B1 adjustments: north facade

Response to Department of Planning Comments

Sketch B1 view showing:
A: location and extent of additional glazed curtain wall along Central Avenue - replaces solid wall cladding
B: previous awning structure over external carparking has been replaced with a much smaller cantilevered element

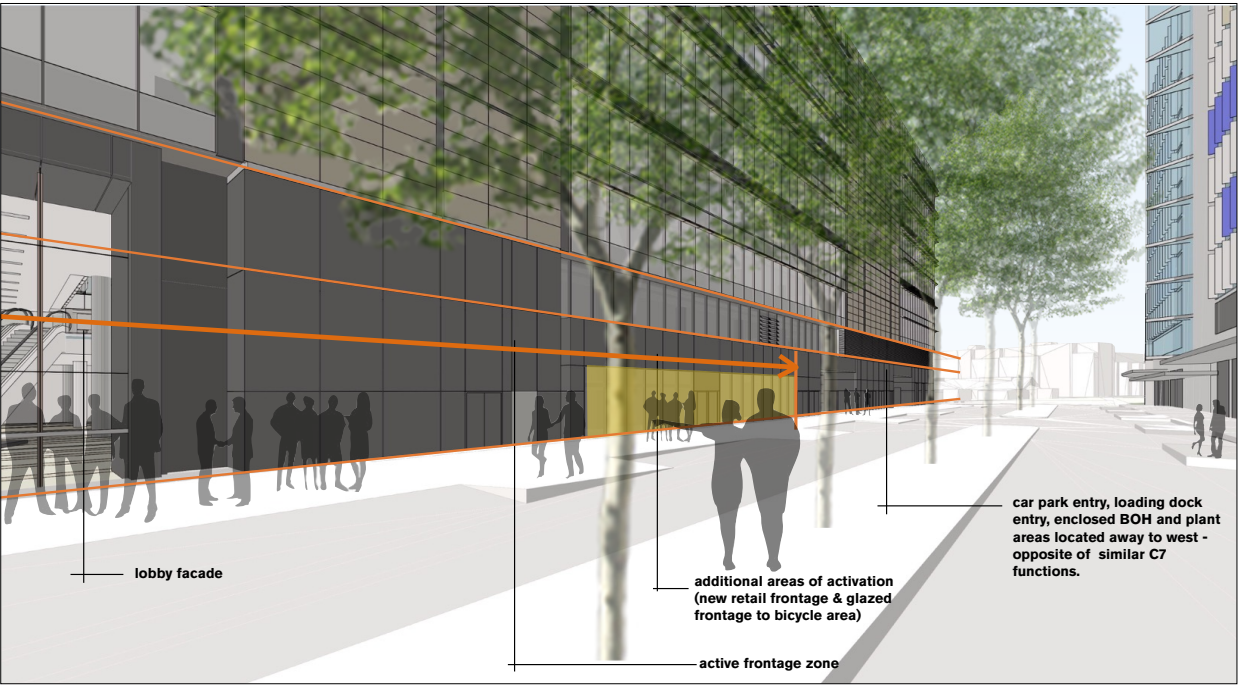
- Additional glazed frontage along Central Avenue: retail tenancy and bicycle area.
- Additional glazing to the western end of the north floorplate - Level 01 - 07.

B1 sketch view: modified SSDA proposal with reduced extent of roof top plant

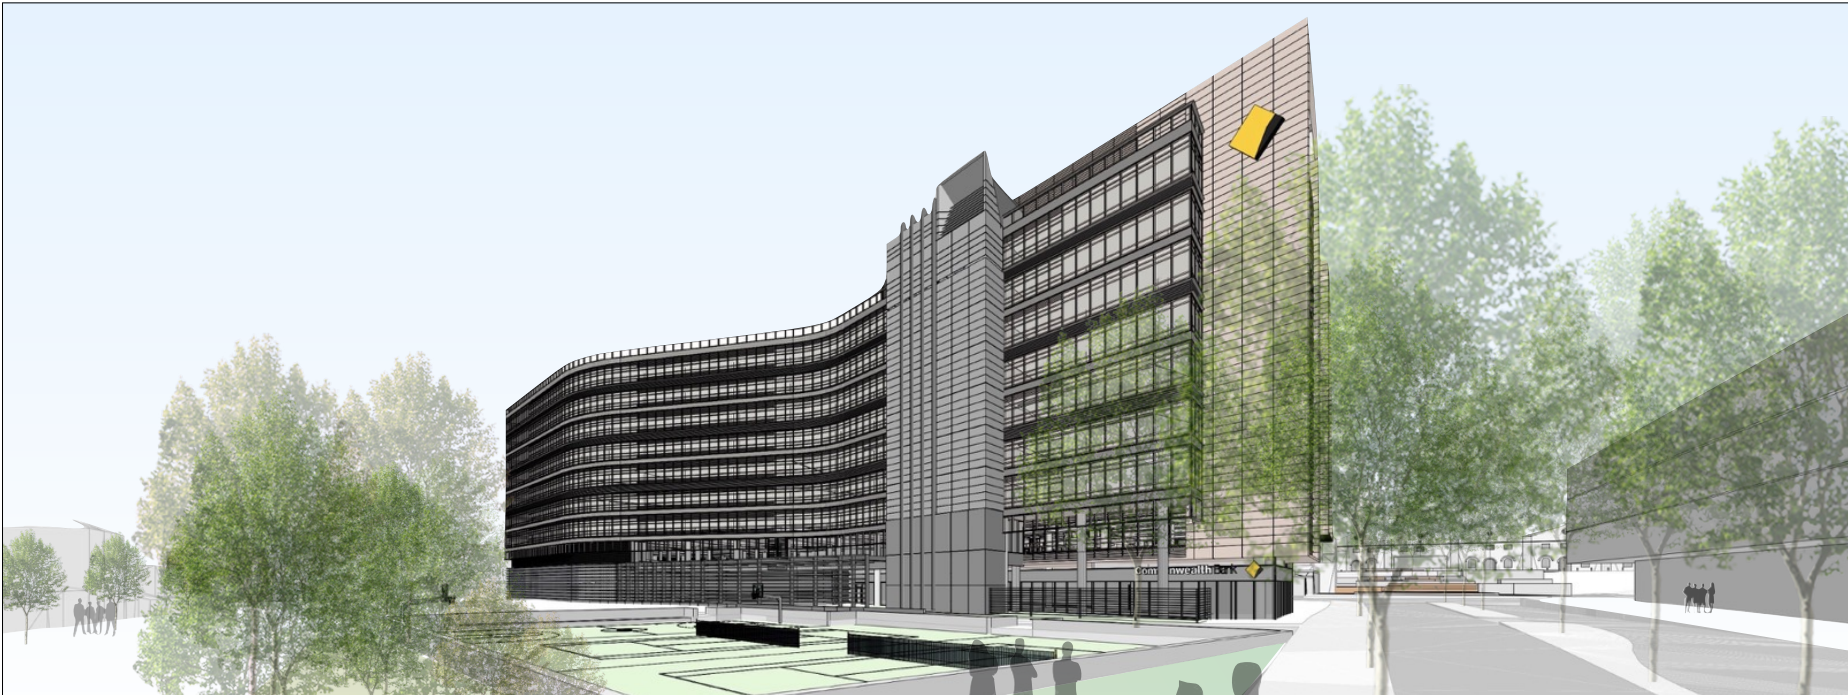
Key Issue 1 Building form and design - Building 1
Further consideration should be given to options that reduce the actual or perceived east I west length of Building 1, including architectural design features, recesses and building articulation. Further consideration should be given to the internal arrangement of building 1 to increase activity on the north and south facades, including further consideration given to: — how the car park, plant and two cores on the north elevation could relate more positively to the desired 'high street' character of Central Avenue and the orientation of the Channel 7 building; and — how the car park on the south elevation could provide an active facade to the adjacent public domain. In addition to the proposed building height coordinates requested by Sydney Airport, please provide further clarification of any potential impacts of the building should it enter protected airspace.

Response to items as above: B1 south facade: As noted in the original SSDA submission Design Report: <i>....from Henderson Road the building is characterised by the sweeping, sinuous forms of the southern façade. This provides a distinctive character to the precinct upon approach from Henderson Road. The south eastern core projects beyond the line of the curved southern elevation to form the single vertical element in this facade. This vertical expression is positioned at the east of this elevation forming a distinctive, landmark element on approach from the south."</i> <i>....Building 1 is characterised by the sweeping, sinuous forms of the southern façade. This provides a distinctive character to the precinct upon approach from Henderson Road. The curved plan form of Building 1 is extended inside to generate an architectural expression unique to Building 1.</i> The addition of architectural features or articulation to the southern facade is not in accordance with the design intent to create a clean, sweeping, sinuous form as noted above. The screen element to the carpark is formed from a series of refined, horizontal metal blades that accentuate the horizontal lines of the south facade. Inset cladding panels allow the density of the screen to be varies in response to technical requirements while also allowing for patterning and articulation. Opportunities to integrate landscaping and artwork into this screen will be further explored during design development. In addition to the proposed building height coordinates requested by Sydney Airport, please provide further clarification of any potential impacts of the building should it enter protected airspace. Refer to separate information as supplied by Mirvac.
